19 October 2011

Stage 1a Basement Design Change - Amended Remedial Action Plan, Other Remediation Works South Area, Hickson Road, Millers Point, NSW

Figure 1 – Schematic Cross Section A-A' based on superseded Basement Design

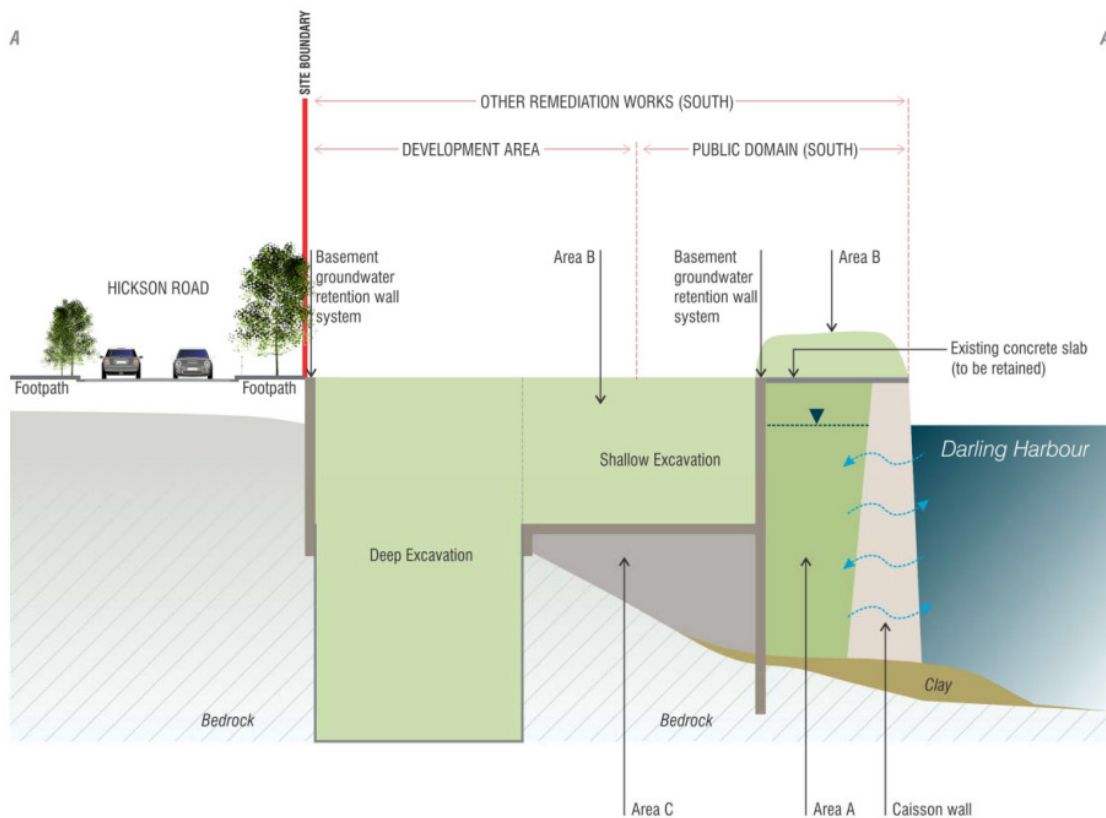
The Shallow and Deep Excavation areas are diagrammatically illustrated in **Figure 1** below (which is a cross section taken from Section 1.3.1 of the Amended RAP). The alignment of this cross section is detailed in the attached **Figure F3**.

Figure 2 – Amended Schematic Cross Section A-A'

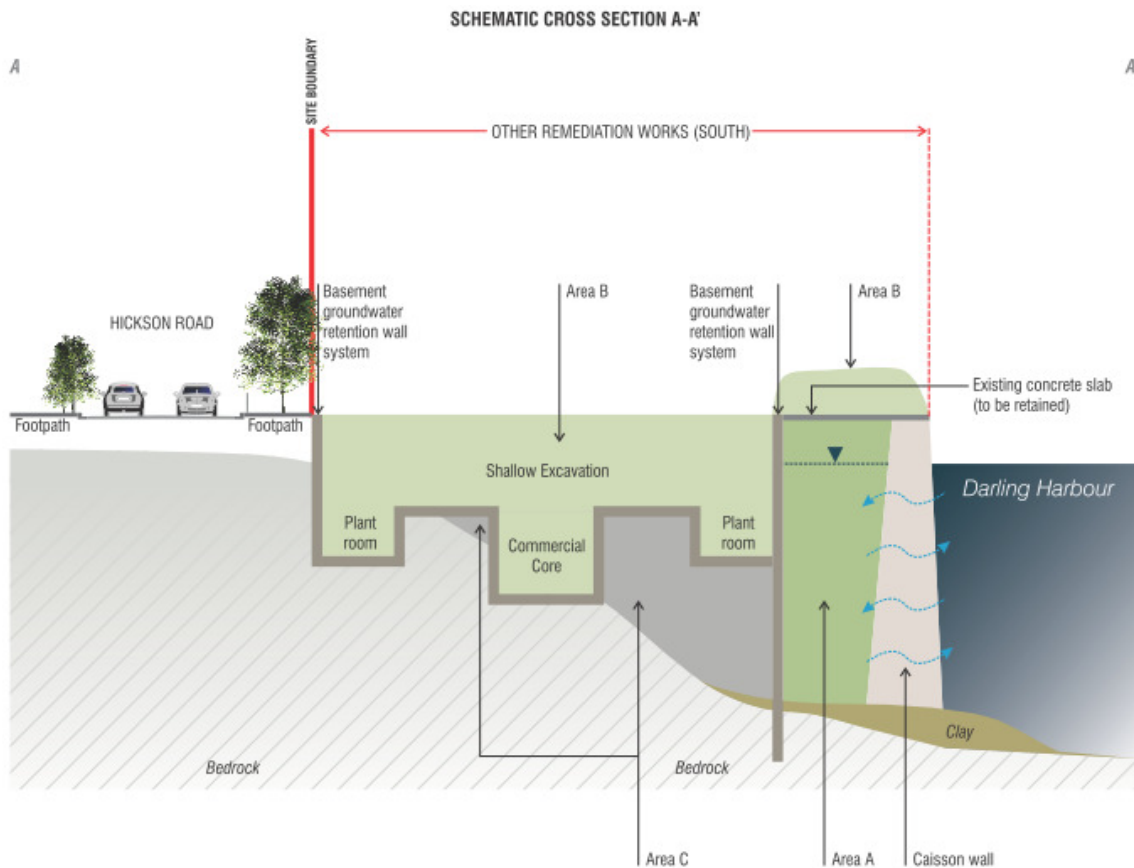
The revised basement excavation, based on the proposed changes, is diagrammatically illustrated in **Figure 2** overpage. The alignment of this cross section is detailed in the attached **Figure F3**.

- As the former Deep Excavation area is now planned to be excavated to depths ranging between RL -5.3 m AHD and RL -10.4 m AHD instead of RL -20 m AHD, a larger volume of fill and natural material will remain beneath the basement in the eastern portion of the Site (i.e. Area C on **Figure 2** above);

- The volume of materials to be removed as part of basement excavations (i.e. Area B on **Figure 2** above) will be reduced; and
- The lateral alignment of the basement groundwater retention wall system has not changed. Consequently, the proposed changes to the basement design will not change the existing data analysis presented in the Amended RAP for:
